**RE: Comments of Friends of the River et al. on the Del Puerto Canyon Reservoir  
Partially Recirculated Draft Environmental Impact Report (SCH #2019060254)**

Friends of the River (“FOR”) is California's statewide river conservation organization dedicated to preserving and restoring California's rivers, streams, and their watersheds. FOR submits these comments on Del Puerto Water District’s Del Puerto Canyon Reservoir *Partially Recirculated Draft Environmental Impact Report*, SCH# 2019060254 (“PRDEIR”), on behalf itself, Sierra Club Mother Lode Chapter, Center for Biological Diversity, Save Del Puerto Canyon, Save Mount Diablo, and Mount Diablo Bird Alliance.

**Figure 1. Figure 3.4-6 from the PRDEIR: Del Puerto Creek Flows 2000-2025 (cfs)**

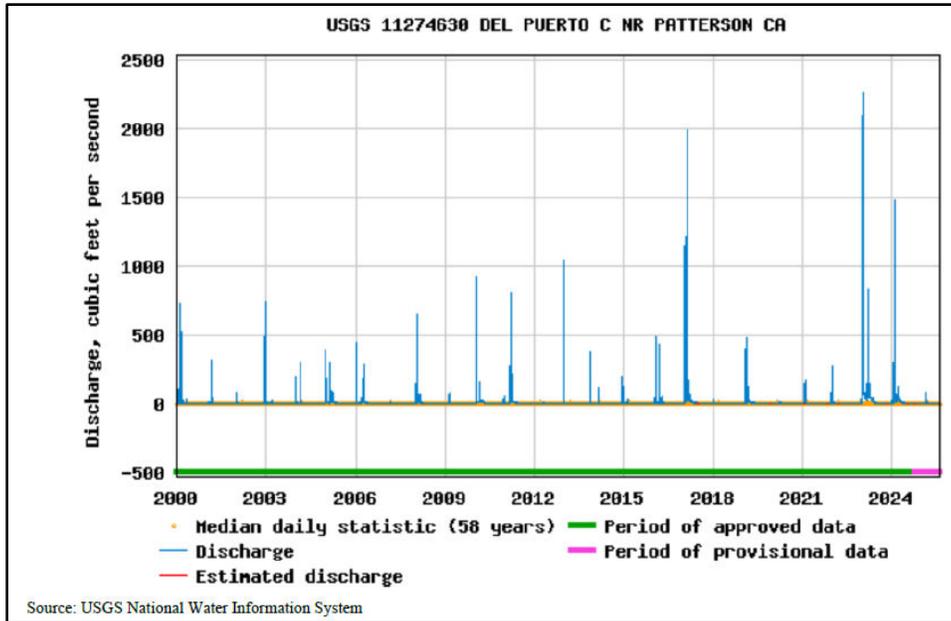
A central premise of the PRDEIR is that downstream terrestrial habitats are already sustained primarily by agricultural return flows and operational spills, and that these inputs will continue to maintain downstream conditions with the Project in place (see footnote 11). However, the PRDEIR does not adequately analyze the variability or reliability of those inputs over time, particularly during drought conditions, changing cropping patterns, or operational adjustments that are reasonably foreseeable over the life of the Project.

Treating return flows and spills as effectively constant background conditions, the PRDEIR understates the risk that reductions or timing shifts in those flows could exacerbate drying, reduce riparian soil moisture, or impair downstream habitat during critical life history periods for terrestrial species. Even further, the PRDEIR itself demonstrates that the Del Puerto Creek system is pulse flow-driven (figure pasted below from p. 3.4-25).

**Figure 2. National Park Service GPS data showing locations of Condors in September 2023. Star indicates approximate location of Del Puerto Canyon, oval indicates approximate location of PRDEIR Study Area.**

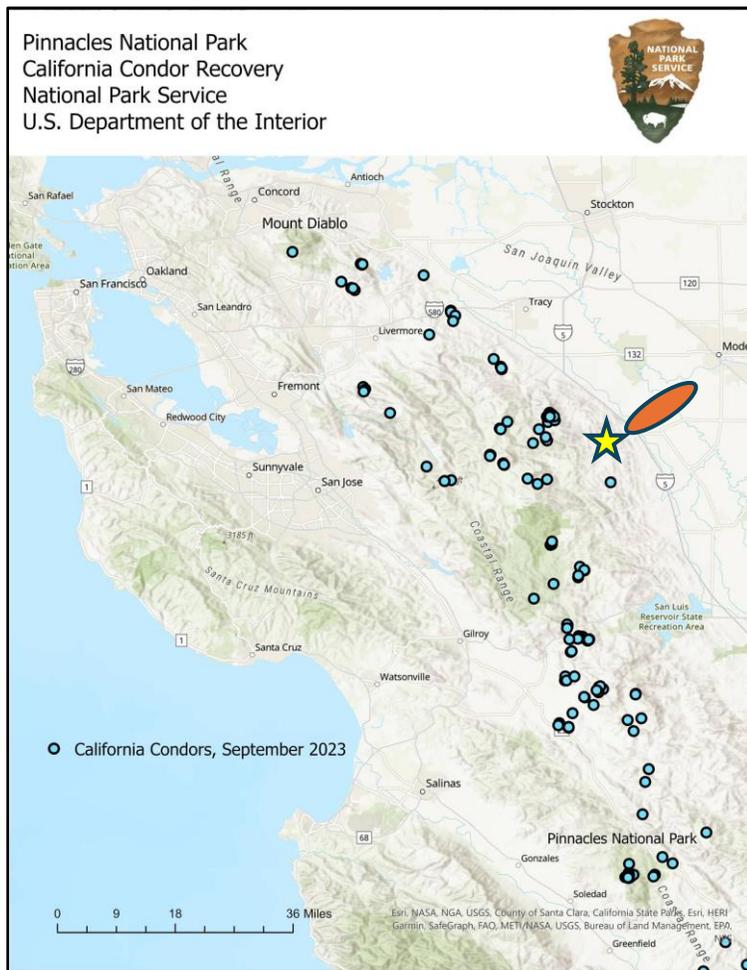
The PRDEIR excludes the California condor (*Gymnogyps californianus*), a special-status wildlife species, from analysis because it is “not expected to occur within the study area due to the absence of recorded occurrences and lack of suitable habitat.” However, recent evidence indicates that condors use the northern Diablo Range, including areas near Del Puerto Canyon. Reports in late 2023 documented multiple California condors soaring over northern Contra Costa and Stanislaus counties, with individuals tracked over and near Mount Oso just north of Del Puerto Canyon.<sup>19</sup> Further, data from the National Park Service demonstrates that condors originating in Pinnacles National Park use the Diablo Range extensively (see Figure 2 below).<sup>20</sup>

**Figure 3. Portion of USFWS map of the California condor’s geographic range (green)**

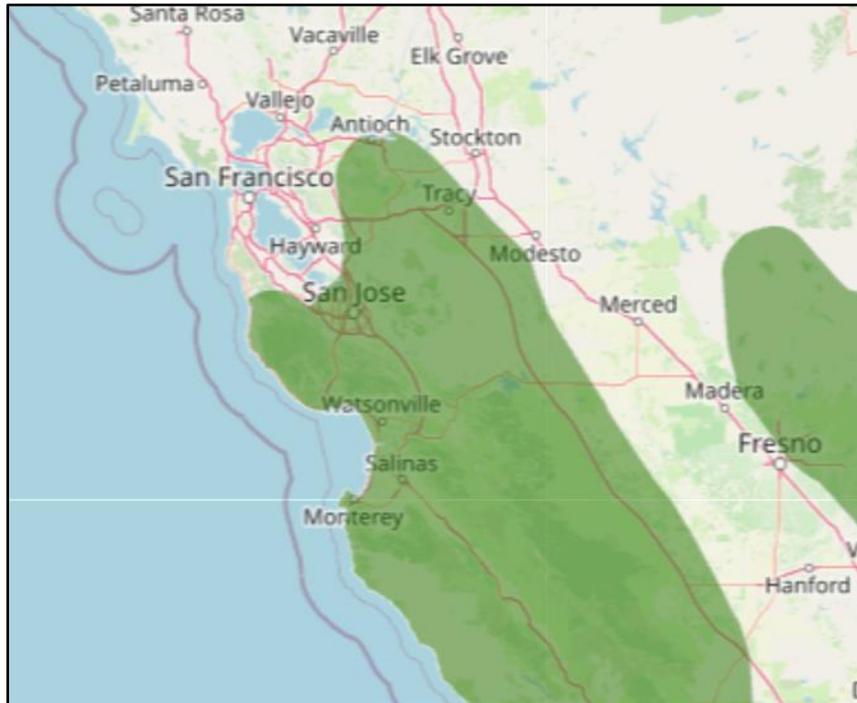
Further, California condors are known to fly more than 124 miles in a single day,<sup>21</sup> and their home range size varies from 200-400 square miles throughout the year.<sup>22</sup> Therefore, the Study Area of the PRDEIR is well within the home range of the condors inhabiting Diablo Mountain Range and Pinnacles National Park. In fact, the United States Fish and Wildlife Service (USFWS)—the agency responsible for protecting listed species including the condor—has included the Study Area within the species’ geographic range (Figure 3).<sup>23</sup>

The PRDEIR’s claims that the Study Area does not contain suitable habitat for condors is not supported by evidence or adequate analysis. In fact, grassland, which constitutes 17% of the Study Area, is listed as important foraging habitat in the 1996 USFWS Recovery Plan for the
